緊急現場安全通知**醫療器材矯正****URGENT FIELD SAFETY NOTICE****MEDICAL DEVICE CORRECTION**

“德塔斯” 主動脈氣球導管幫浦(衛部醫器輸字第 025453 號)
Datascope Cardiosave Hybrid and Rescue Intra-Aortic Balloon
Pumps (IABP)

Datascope Corp., a subsidiary of Getinge is initiating a voluntary Medical Device Correction for the Cardiosave Hybrid and Cardiosave Rescue Intra-Aortic Balloon Pump (IABP) due to four issues that could affect IABP performance:

Figure 2: As pictured in Cardiosave Hybrid and/or Rescue Operating Instructions

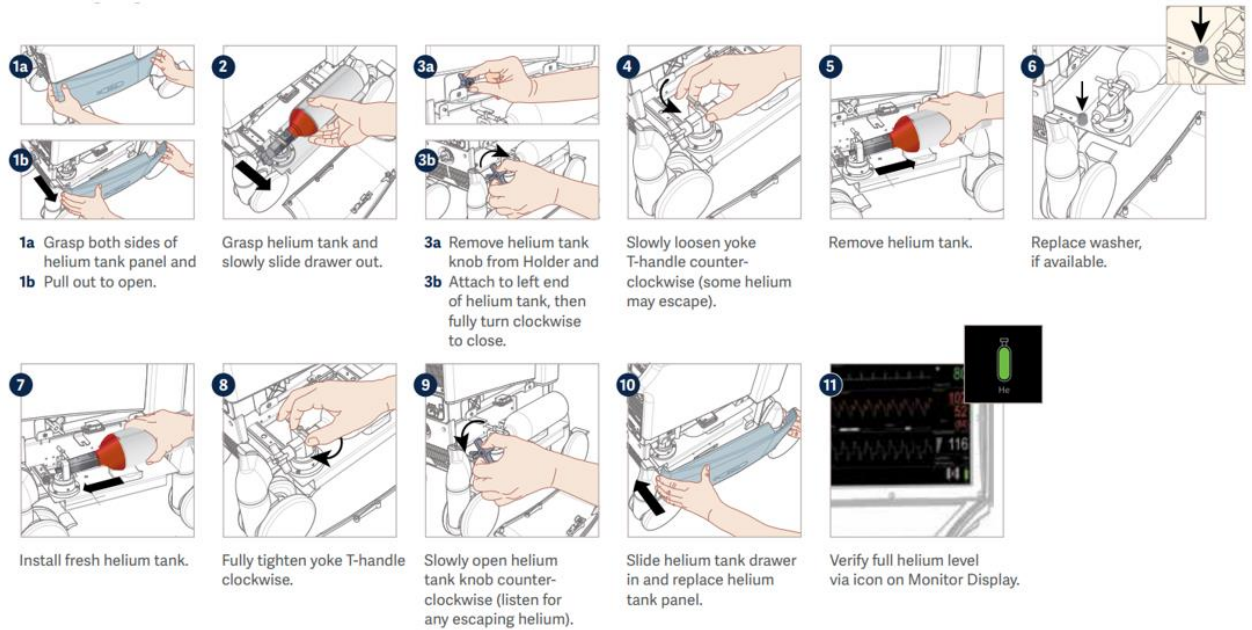
據報告，高壓氦氣調節器出現故障可能會導致 Cardiosave 醫院推車發生氦氣洩漏。高壓氦氣調節器位於 Cardiosave 醫院推車中，用於調節外部氦氣供應的氦氣壓力。如果氦氣調節器出現故障，幫浦控制台的內部氦氣儲存器在停靠到受影響的醫院推車時不會得到補充。這可能會導致內部儲存器內的氦氣量不足。請參考下面的圖片以供參考。

There have been reported failures of the high pressure helium regulator which may cause a helium leak in the Cardiosave Hospital Cart. The high pressure helium regulator is located in the Cardiosave Hospital Cart and regulates the helium pressure of the external helium supply. In instance of helium regulator failure, a Pump Console' s internal reservoir of helium will not be replenished when docked into an impacted Hospital Cart. This may result in an insufficient amount of helium within the internal reservoir. Please refer to images below for reference.

1. 在按照 Cardiosave 操作說明安裝和更換氦氣罐期間，請確保在插入和/或移除氦氣罐時注意不要損壞氦氣罐或氦氣罐支架。

During Installation and Replacement of Helium Tank per the Cardiosave Operating Instructions, please ensure care is taken not to damage the helium tank or the helium tank yoke while inserting and/or removing the helium tank.

If user observes any visual damage on High Pressure Regulator, please contact your Datascope/Getinge service representative.

Figure 3: Drawings as pictured in *Cardiosave Hybrid and/or Rescue Operating Instructions*, along with a final picture of the O-ring as it appears on the unit.

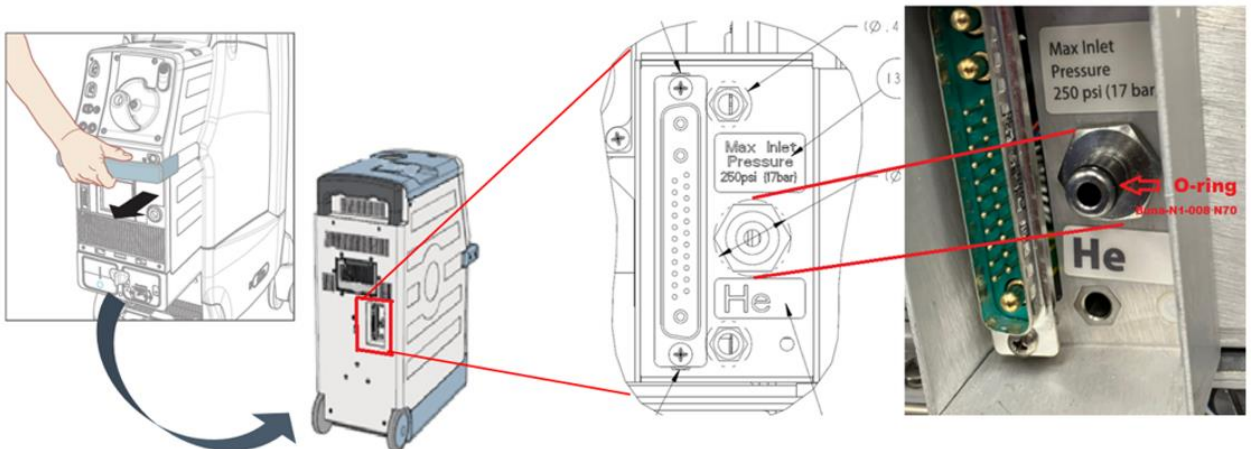
There have been reports of damaged, worn, or torn O-rings on the Cardiosave Pump Console quick disconnect fitting resulting in helium tank leaks. The quick disconnect fitting is the point of connection that permits the refilling of the Pump Console' s internal helium reservoir when the Pump Console is docked in the Hospital Cart. Please refer to images below for reference.

If user observes any visual damage to the O-ring installed as part of the quick disconnect fitting, please contact your Datascope/Getinge service representative. If possible, remove the IABP from patient use until appropriate repairs can be made.

Datascope/Getinge is currently updating the annual Preventive Maintenance instruction to include replacement of the quick disconnect fitting O-ring.
